Fixing defective units tutorial

Introduction

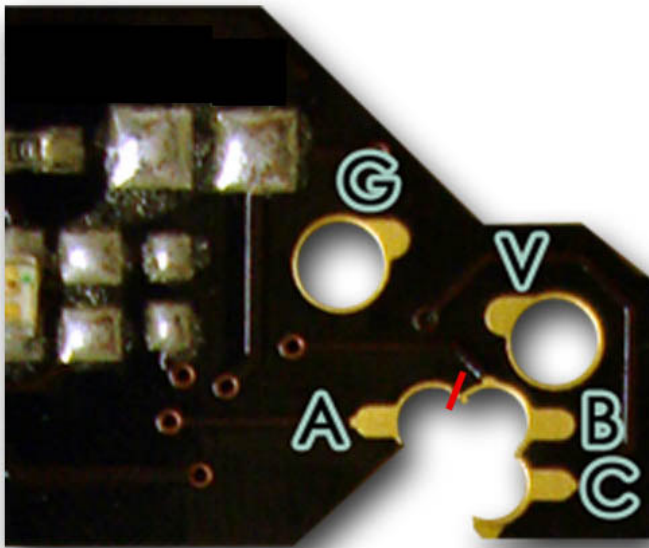
1. Carefully make a first incision between point A and B

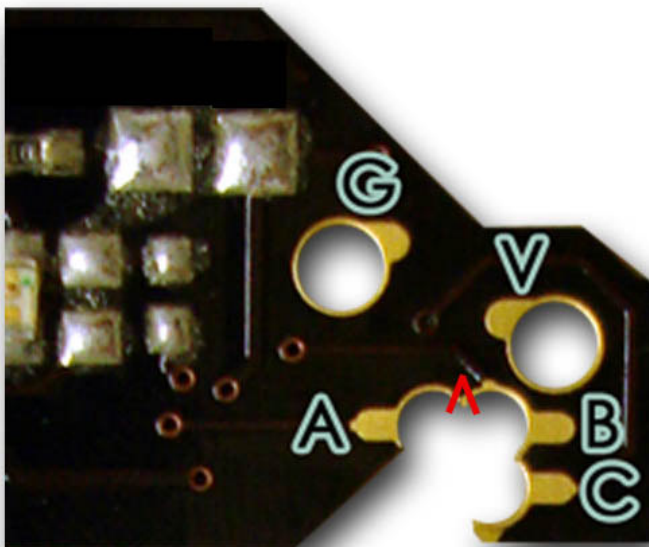
2. Make a second incision between point A and B

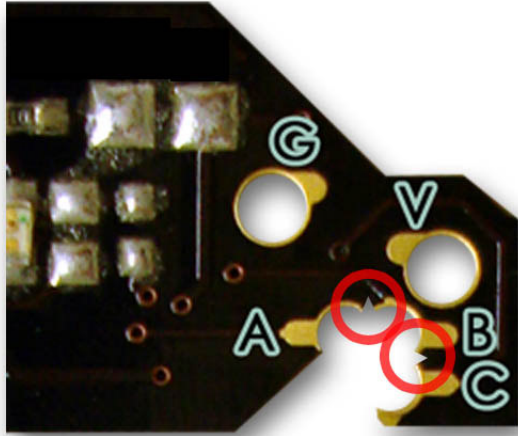
3. Repeat the same operation between points B and C
4. Verify that there is no electrical contacts left between A, B and C.

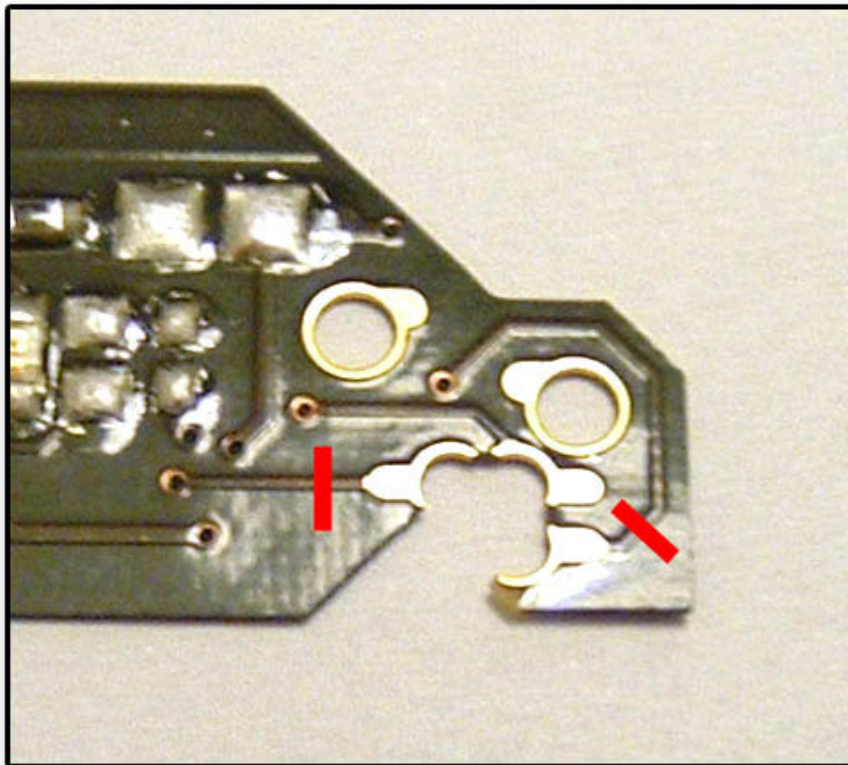
1. Use a cutter to carefully cut the A and C traces, as shown in red

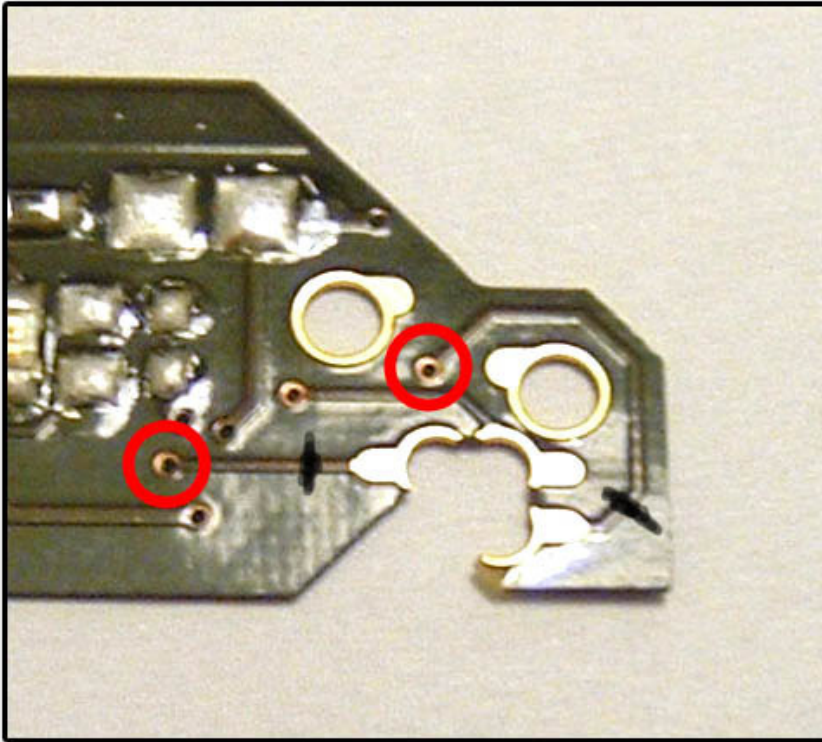
2. Scratch the two vias shown in red to remove soldermask

3. Connect wires from the exposed vias to the drive's A and C points. Point B can be connected as usual.
